HISTORIC AND DESIGN REVIEW COMMISSION

February 15, 2017

HDRC CASE NO: 2017-034
ADDRESS: 815 QUITMAN ST
LEGAL DESCRIPTION: NCB 1255 BLK 3 LOT S 11.5 FT OF 39 & W 49.5 OF 42 ARB 42C
ZONING: C-2
CITY COUNCIL DIST.: 2
DISTRICT: Government Hill Historic District
APPLICANT: Mark Sullivan
OWNER: Monique Sullivan
TYPE OF WORK: New construction
REQUEST:

The applicant is requesting a Certificate of Appropriateness for approval to construct a one-story commercial structure, approximately 2400 square feet, with a stucco exterior and a metal roof.

GARAGE DOOR FAUX WOOD

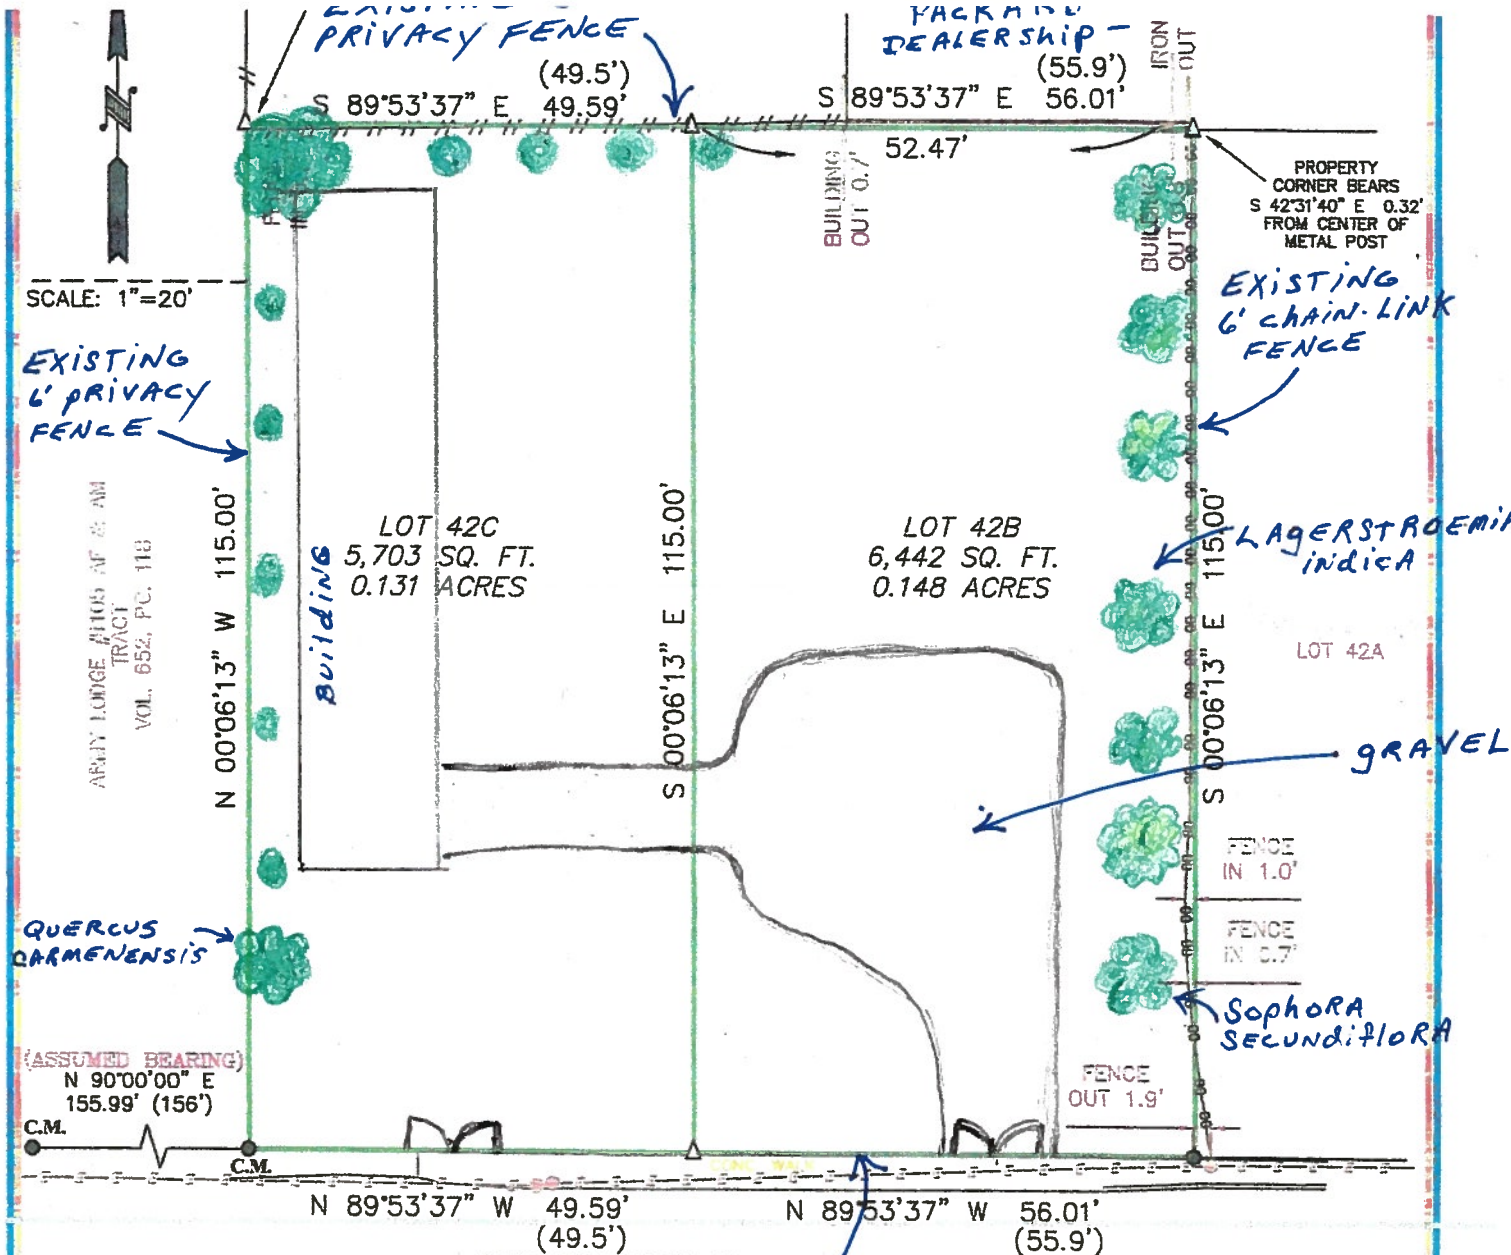
- j. **MATERIALS** – The proposed commercial structure will have stucco siding, wood trim, and a standing seam metal roof. The stucco will be painted white, and the trim and accents will be painted dark brown. The windows are made of wood, and the roll-up door and pedestrian door are made of steel with a faux wood finish. According to the Guidelines for New Construction 2.A., new materials should complement the type, color, and texture of materials traditionally found in the district. Staff finds the proposed stucco, metal roof and wood elements consistent with materials in the district, and the proposal consistent with the Guidelines. Staff finds the proposed door material appropriate, but finds the faux wood finish not appropriate as it is not compatible with the historic district. A steel roll-up door and pedestrian door with minimal detail would be more appropriate.

3. Including a pedestrian door made of wood and providing details.
4. Increasing fenestration along the front façade so that it is consistent with other historic buildings in the district.
5. Including a flat roof form.
6. Adding additional architectural details.

EAST ELEVATION

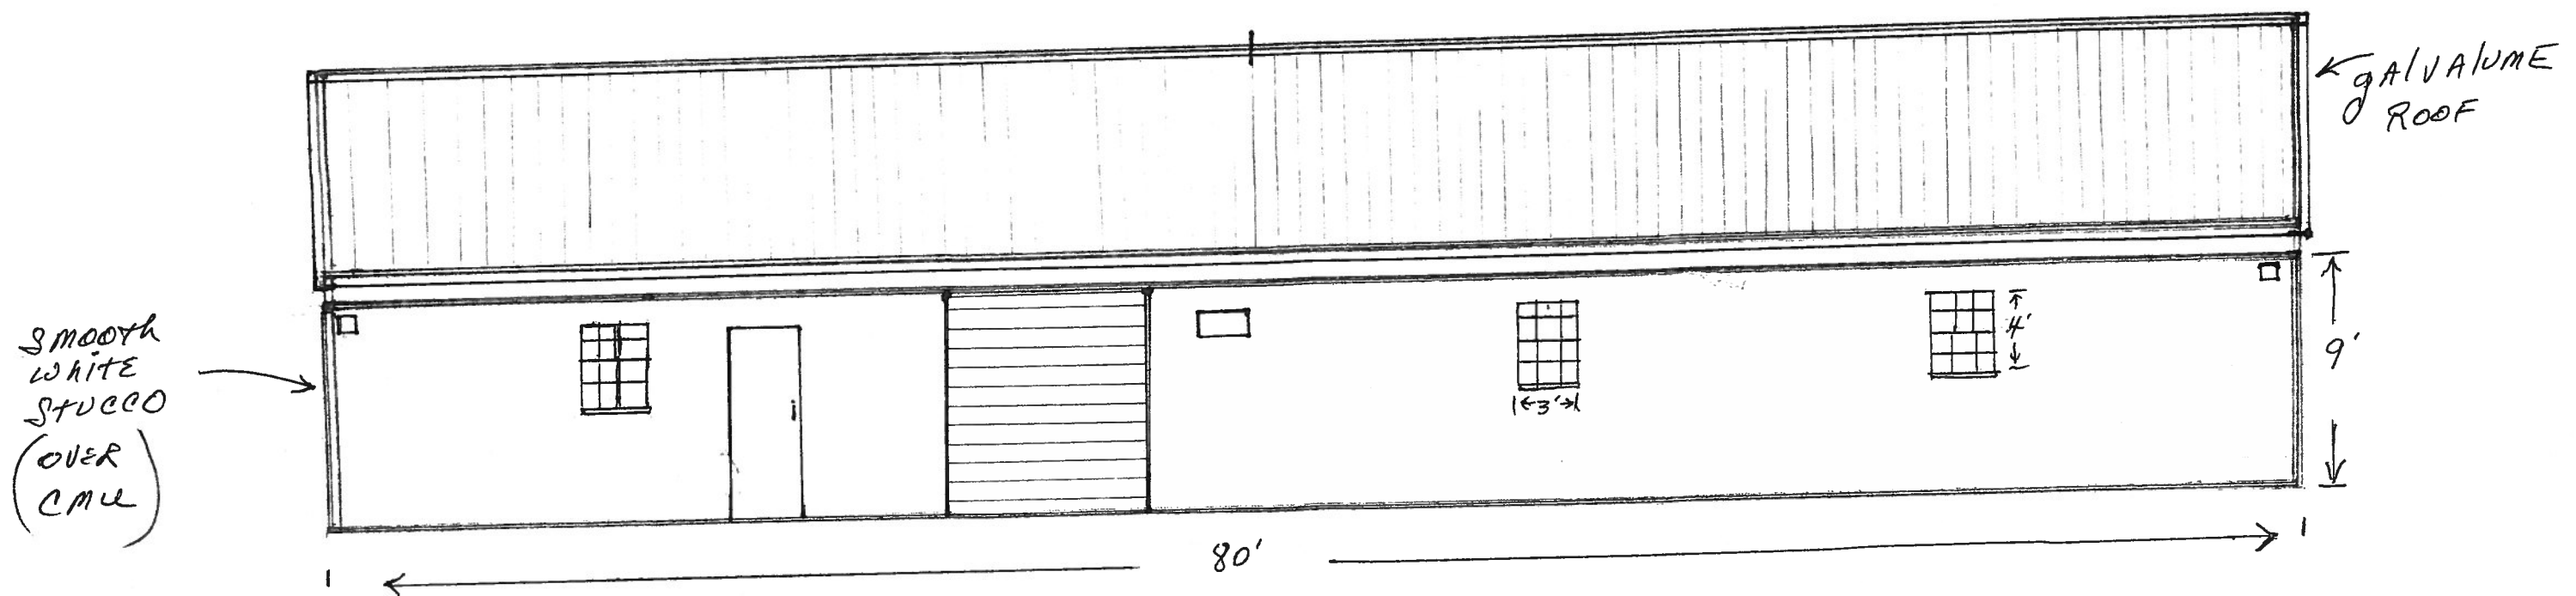
- e. **SETBACKS/ORIENTATION** - The proposed commercial structure is setback 27 feet from the front property line and 8 feet from the left side property line. The proposed front entrance faces east. According to the Guidelines for New Construction 1.A., front facades of new buildings should align with front facades of adjacent building where a consistent setback has been established and the new building should be oriented similar to the predominate orientation of historic buildings along the street frontage. Staff made a site visit January 20, 2017, and found that the historical development pattern does not have a consistent front setback along this block. Also staff found that there is not a predominate orientation along this block; however it is consistent in historic districts for the front entrances should face the street. Staff finds the proposed setback appropriate, but does not find the orientation consistent with the Guidelines.

- g. **ROOF FORM** – The proposed structure has a front gable roof with standing seam metal. According to the Guidelines for New Construction 2.B., new buildings should incorporate roof forms in terms of pitch, overhangs, and orientation that are consistent with those predominately found on the block. Staff made a site visit on January 20, 2017, and found that the other two historic structures along the block have flat roof forms. Staff finds the proposed gable roof form is not consistent with Guidelines, and recommends the structure include a flat roof form.

1. Orienting the building to address Quitman.
2. Locating a front pedestrian entrance on the front façade.

ELEVEN ea. 3'x4' windows
ONE ea. 1'x2' bathroom window
ONE ea. 8' roll-up garage door
ONE ea. 36' entry door

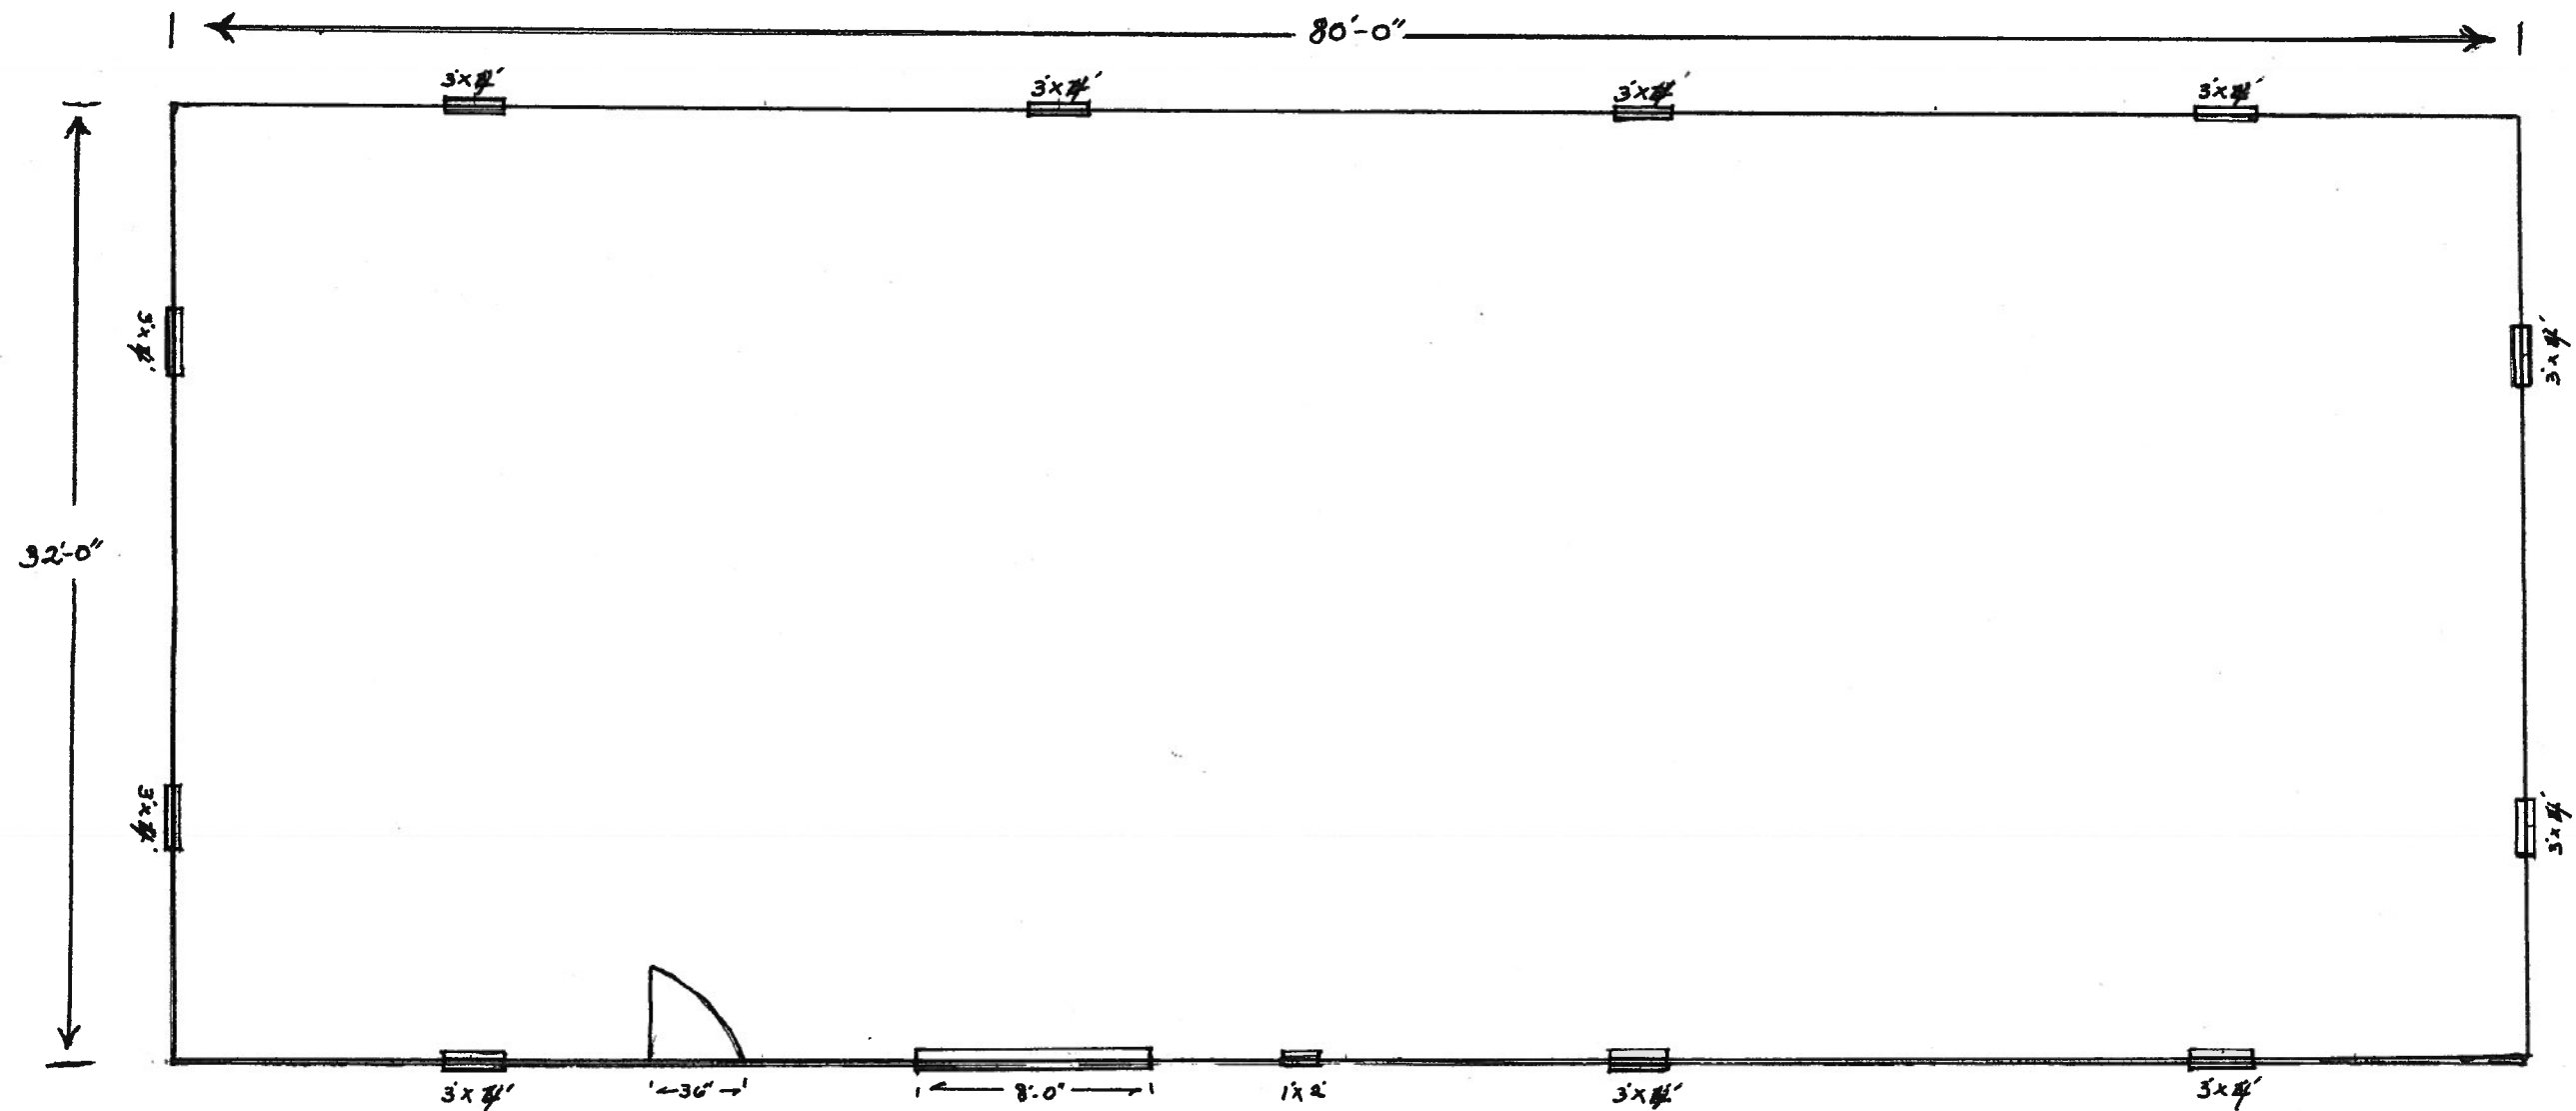
- h. **RELATIONSHIP OF SOLIDS AND VOIDS** – The proposed window fenestration includes 11 4' x 3' six over six wood windows, and one 1' x 2' small fixed wood window to the right of the roll-up door. The doors to be installed will be a metal 8' roll-up door and one 36" pedestrian steel door. According to the Guidelines for New Construction 1.C., incorporate window and doors openings with a similar proportion of wall to window space as typical with nearby historic facades. Staff asked for more details regarding the pedestrian door, but has not received it as of the date of posting. Staff finds the window configuration appropriate, but finds the proposed fenestration minimal and pedestrian doors are typically located along the front façade. Staff recommends that there be a pedestrian entrance along the front façade, that the details of the proposed pedestrian door are provided, and that there is more fenestration consistent with other historic buildings in the district along the front façade.
